**GENOA CHARTER TOWNSHIP
PLANNING COMMISSION PUBLIC HEARING
MONDAY, JUNE 13, 2016
6:30 P.M.
AGENDA**

Attention:	Kelly Van Marter, AICP Planning Director and Assistant Township Manager
Subject:	Seaside Seawalls – Special Land Use and Site Plan Review #2
Location:	Victory Drive – east side of Victory Drive, south of Grand River Avenue
Zoning:	IND Industrial District

Re: Seaside Seawalls Site Plan Review 2

WEST (FRONT) ELEVATION
SCALE: 1/8" = 1'-0"

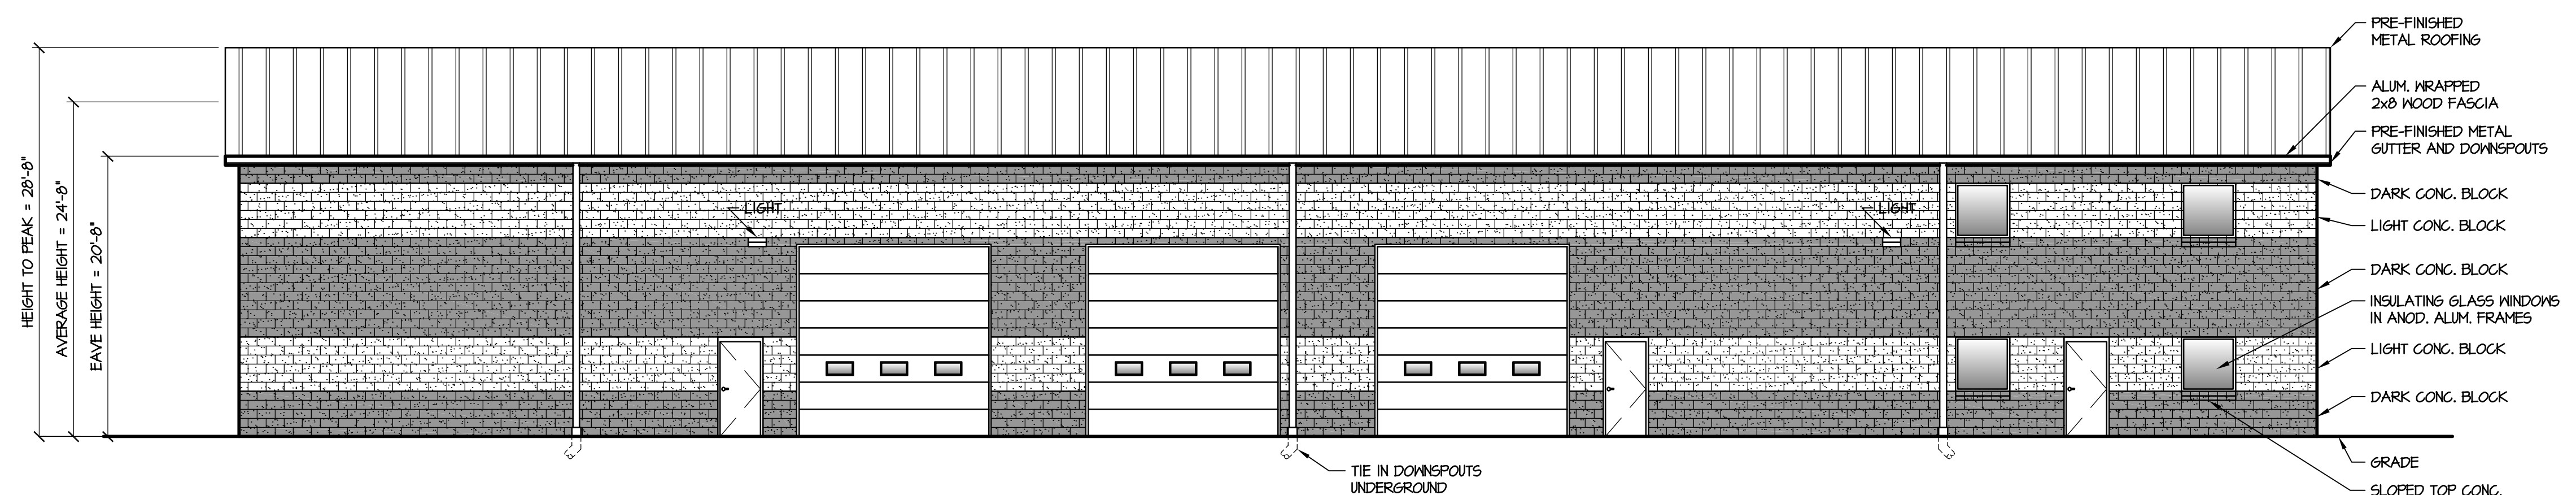
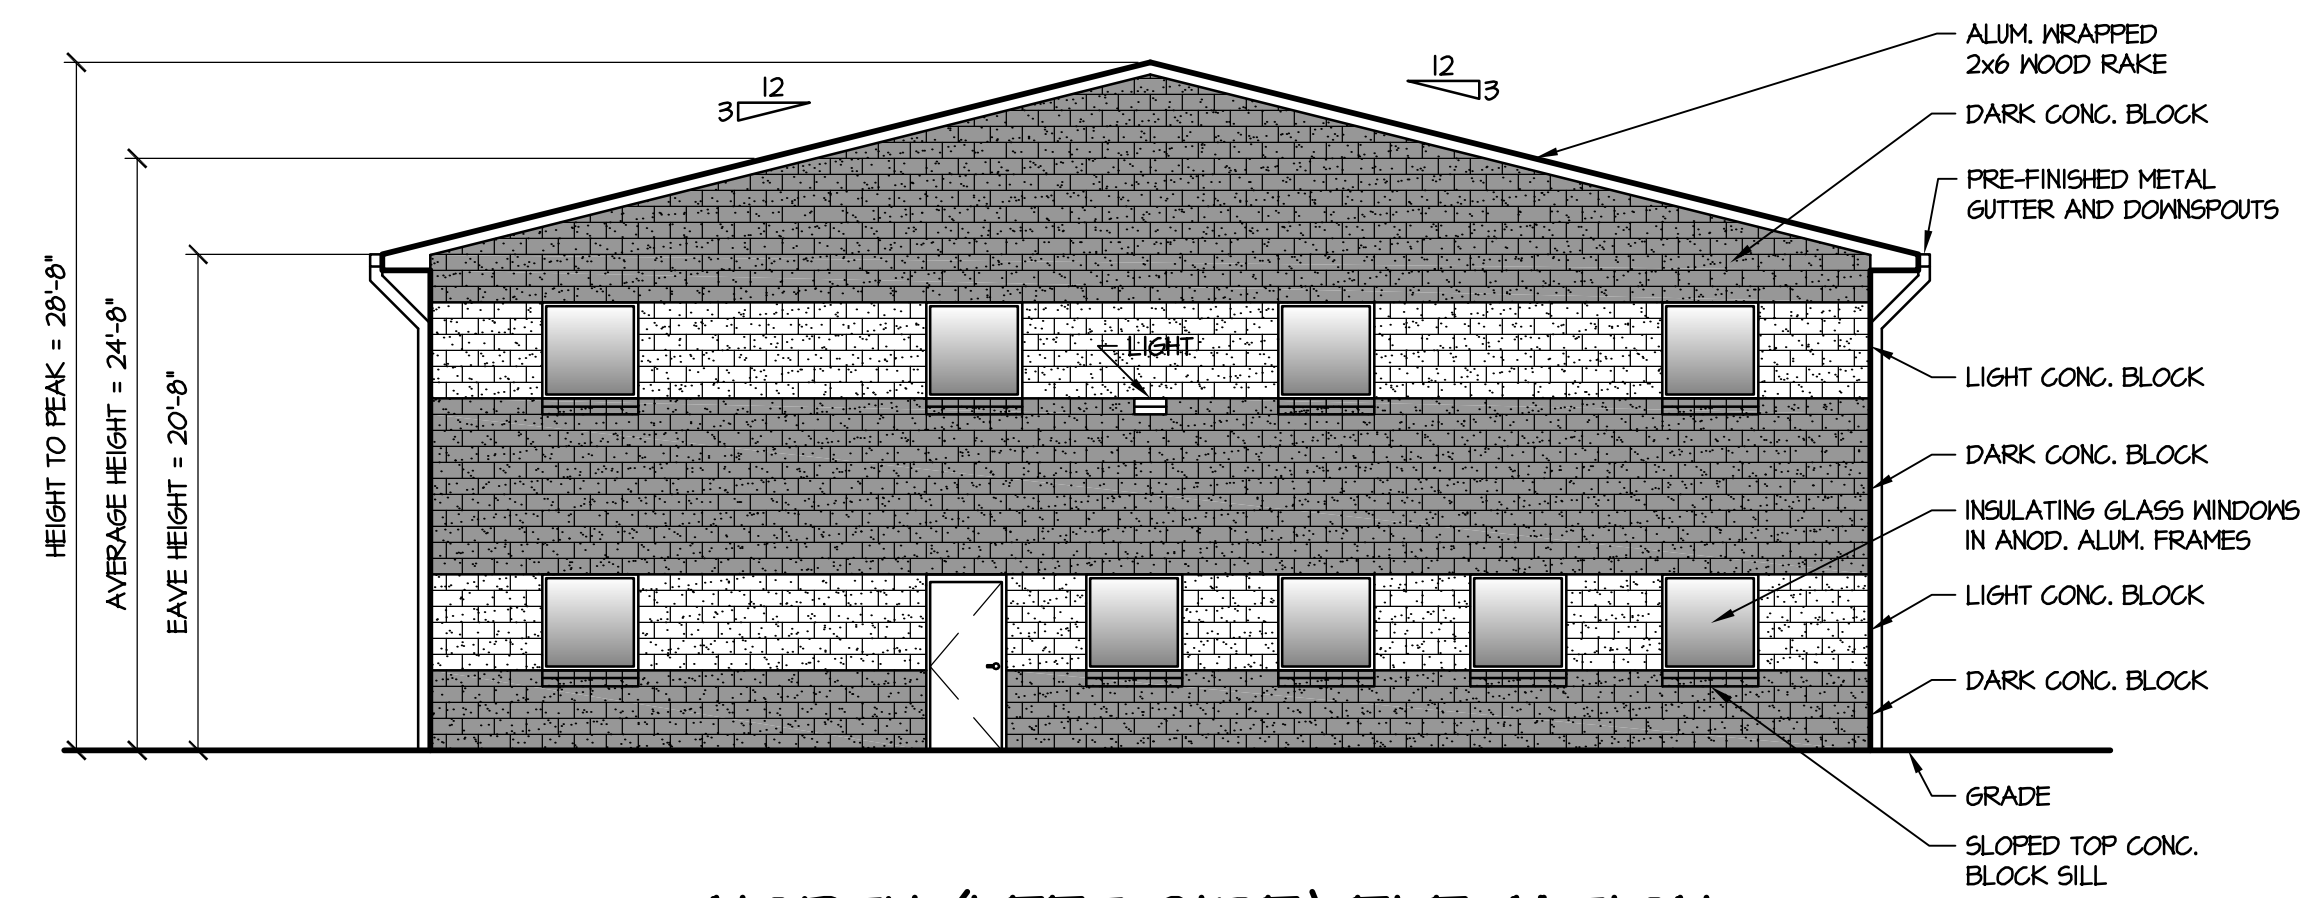
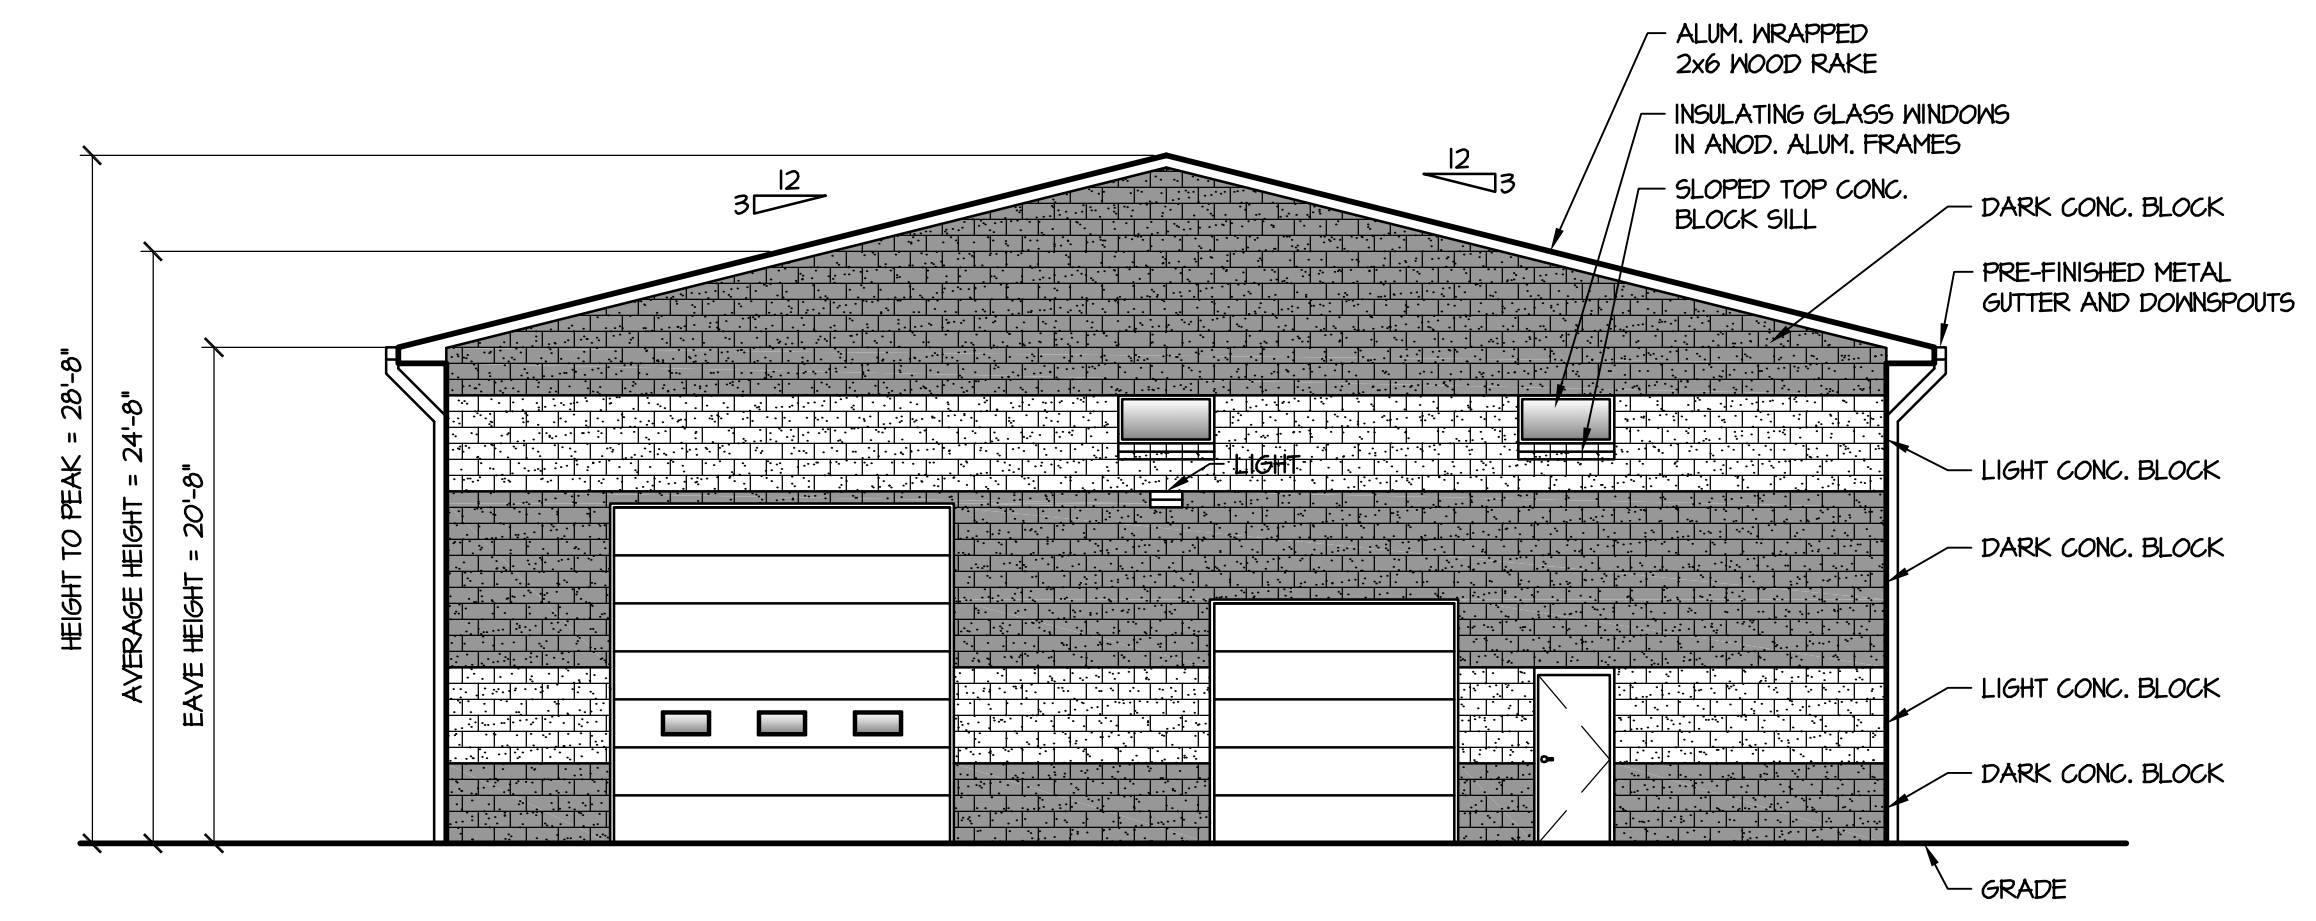
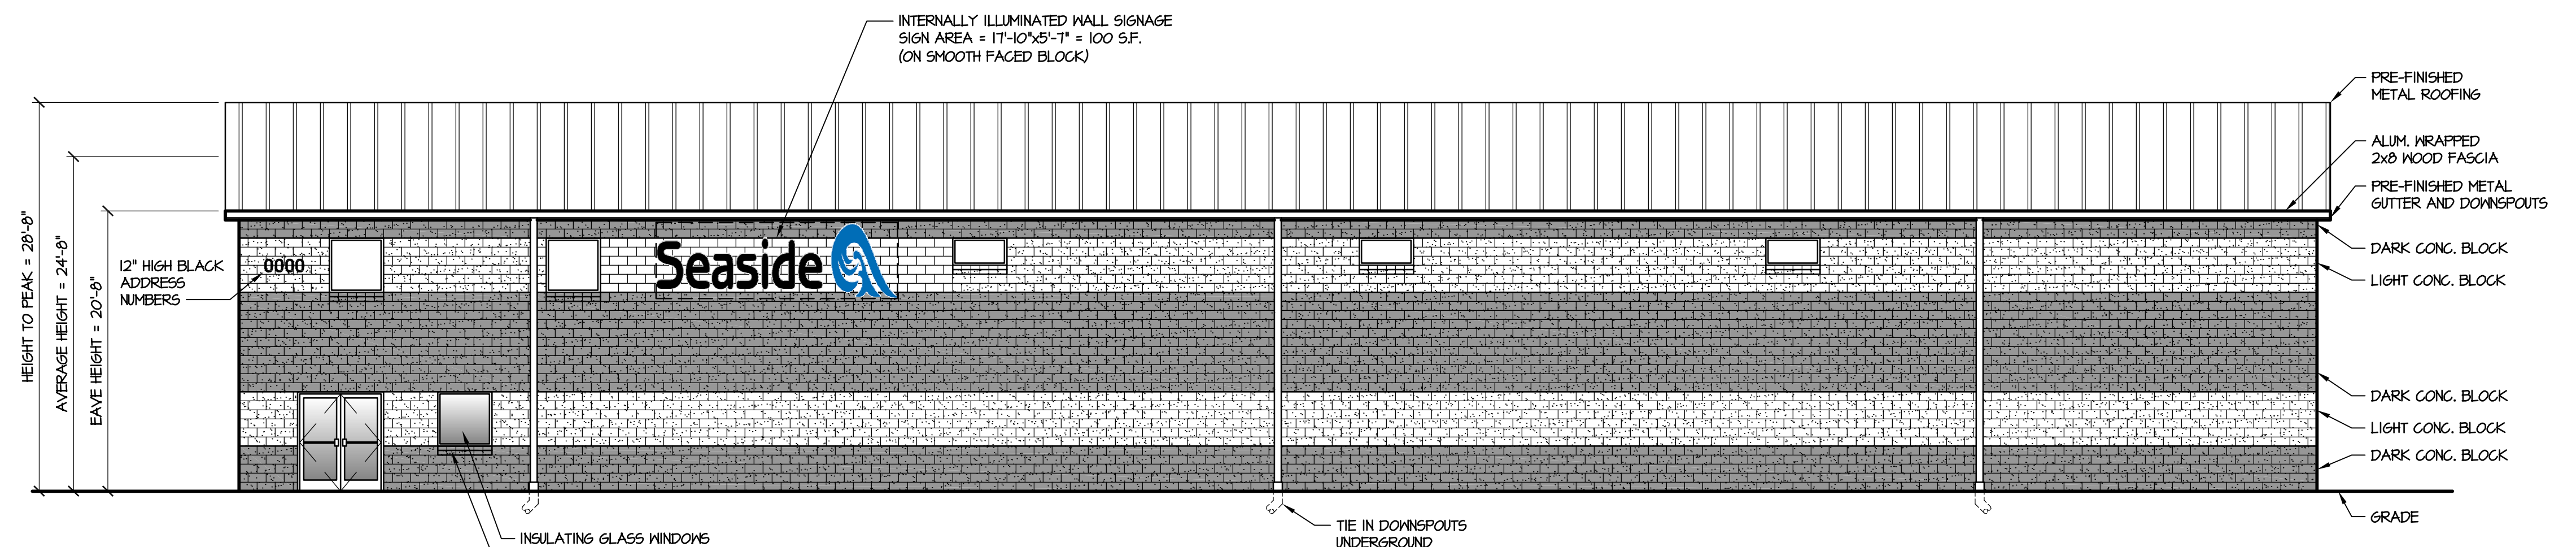
6. The proposed elevations, including colors and materials, are subject to review and approval by the Planning Commission. We request the applicant present a material and color sample board.

7. We recommend the applicant consider some additional architectural treatments to help break up the wall surface and provide a more aesthetic elevation along the street frontage.

2. Building Materials and Design. The proposed elevations, including colors and materials, are subject to review and approval by the Planning Commission. We request the applicant present the Commission with material and color samples.

Lastly, the front of the building is mostly a blank surface. We recommend the applicant consider some additional architectural treatments to help break up the wall surface and provide a more aesthetic elevation along the street frontage.

- 9. Signs.** The site plan does not identify a ground sign; however, the elevation drawings show an approximately 100 square foot wall sign. The proposed sign complies with the standards of Article 16, although the applicant will be required to obtain a sign permit prior to its installation.
